PBMVC 4.24.18

ITEM H.2.

To: Mayor; Aaron Crandall; eclewandow@aol.com; grantxyz@gmail.com; Mike Rewey
Cc: Monks, Anne; Knepp, Eric; Erdman, Natalie; Stouder, Heather; Phillips, Robert; Dryer, David; Pat Schneider; Dean Mosiman; Bill Novak; jnichols@madison.com; Isthmus Davidoff; bsorge@madisongives.org; lwroge@madison.com; dzweifel@madison.com; N; Mike Ivey; Marc Eisen; Susan De Vos; Yogesh Chawla; madisonareabusadvocates@googlegroups.com; SASYNA-Discussions; ageyer@isthmus.com; Cap Times; kdean@madison.com; jjoyce@madison.com; lchristians@madison.com; selbow@madison.com; abecker@madison.com; jopoiem@madison.com; ldanielson@madison.com; elorenzsonn@madison.com; kferral@madison.com; lspeckhard@madison.com; Joe Tarr; jrath@isthmus.com; dbrogan@isthmus.com; ccapellaro@isthmus.com
Subject: Oppose the Hairball: NO Gargantuan Blair/NoLane/Willy Intersection!

The Pedestrian/Bicycle/Neighborhood LOS-A Plan for Willy/Blair/E.

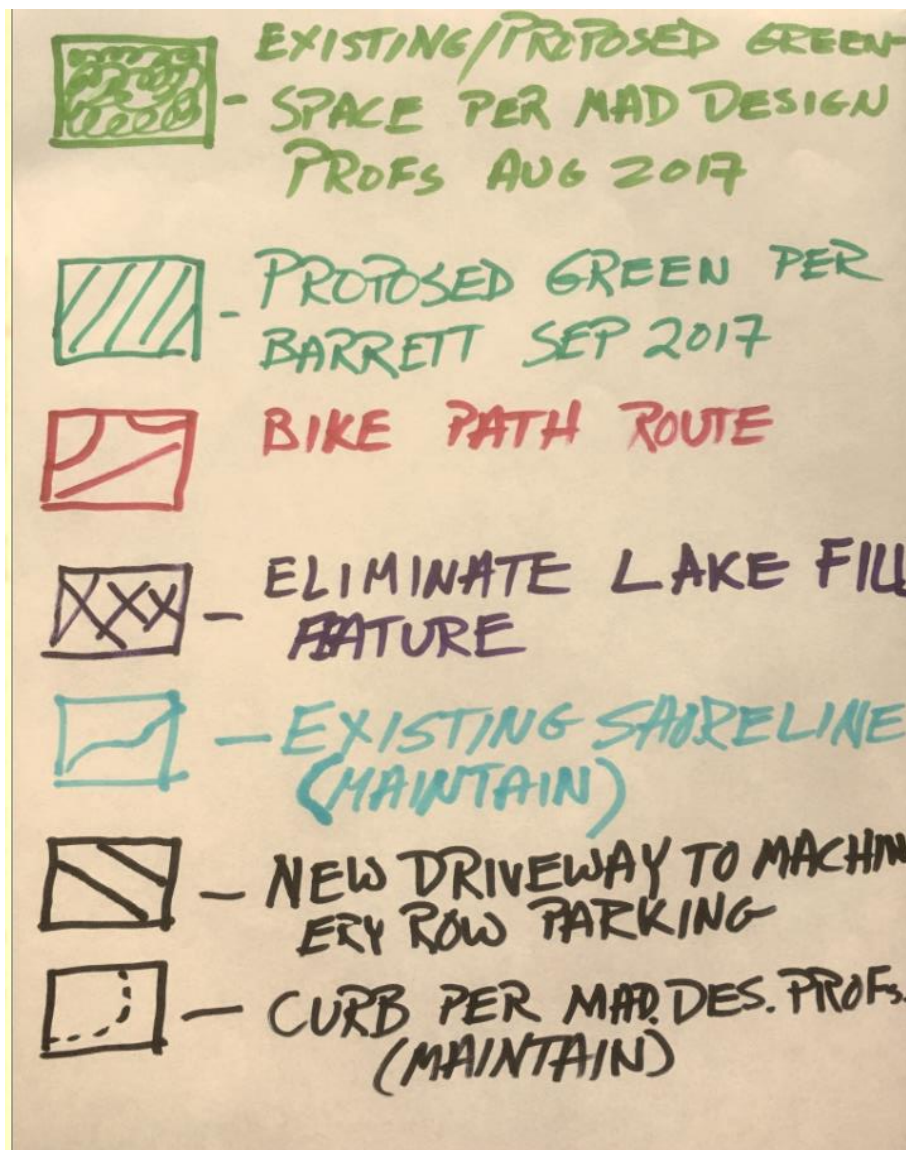
1 – Willy St. returned to it's typical width and configuration as found at Paterson or Baldwin. On-street parking (no rush hour restrictions) the entire length, up to the intersection itself. *NO* expansion of Willy St for the on-street parking. Existing right-most lane converts to parking while expanding space for more trees and bio-infiltration and plaza space. A protected cycle track is accommodated.

2 – Similar to above, E. Wilson returned to a neighborhood-scaled business district street. Curb-curb width less than 1/2. On-street parking, inclusive. All dedicated flying rights eliminated, including the flying right onto JN.

-Entire length of JN->E Wash (and the reverse) is two lanes in each direction *only*. It is about efficiency of traffic operations--MODERATE, lighter, cheaper.

-Northeast/outbound onto E. Wash has one single *dedicated* right turn lane becoming a dedicated lane onto E Wash that is protected from other E-bound traffic. This can be done without any widening. This allows a constant green arrow, except when triggered by a pedestrian. This will keep Blair flowing its entire length, taking pressure off of the hairball intersection (it routinely backs up from E. Wash all the way to the Hairball during rush hour). It is about efficiency of traffic operations--MODERATE, lighter, cheaper.

1, 2 & 3 – Scramble cycle: Entire JN/Blair/Willy/E. Wilson intersection goes green for pedestrians, bikes, rollerblades *only*. This cycle means: All stop for all motor vehicles, no right on red. Peds/bikes can go all directions, including diagonally, across the intersection. It is time to recognize that this is a site of intense pedestrian/bike density (has anyone noticed the many towering apartments that are going up like mushrooms within a block of this intersection?). It is time to bring ped/bike LOS up from its current F status to LOS A.

4 – Bike path ever-so-subtly swerves away from JN. No sharp turns/'dog leg'/chicane as in the "Recommended" Strand plan. A) It makes for a more pleasant and efficient ride (believe it or

5 – New driveway accessing parking behind Machinery Row. (See 4. above). Must go over the significantly tabled bike path after yielding to bike path cross traffic. Driveway is very narrow—+/- 17'. Stack room for 2 cars between JN and bike path.

6 – Eliminate lake fill marina feature. Even using a world-famous architect's cachet should not allow for this travesty. Put the feature over the highway itself, if need be. Preserve our lakes!

7 – Eliminate the left from SW-bound (toward Monona Terr) onto Law Park boat ramp parking. It is a disaster in the making for everyone involved.

Permit U-turns at the Monona Terrace stop light for "jug handle"* access back to Machinery Row. (*Oh yes, this is a term of art in the traffic engineering world; there is a "jug handle" way out on Mineral Pt Rd, near the westside Menards/Target area.) This will require traffic waiting to exit the ramp and enter JN to wait for a specific green arrow, no right on red (to avoid crashes with U-turners on JN).

8 – Significantly expanded greenspace by eliminating the anachronistic boat ramp, and returning Williamson St and E. Wilson St to neighborhood scale.
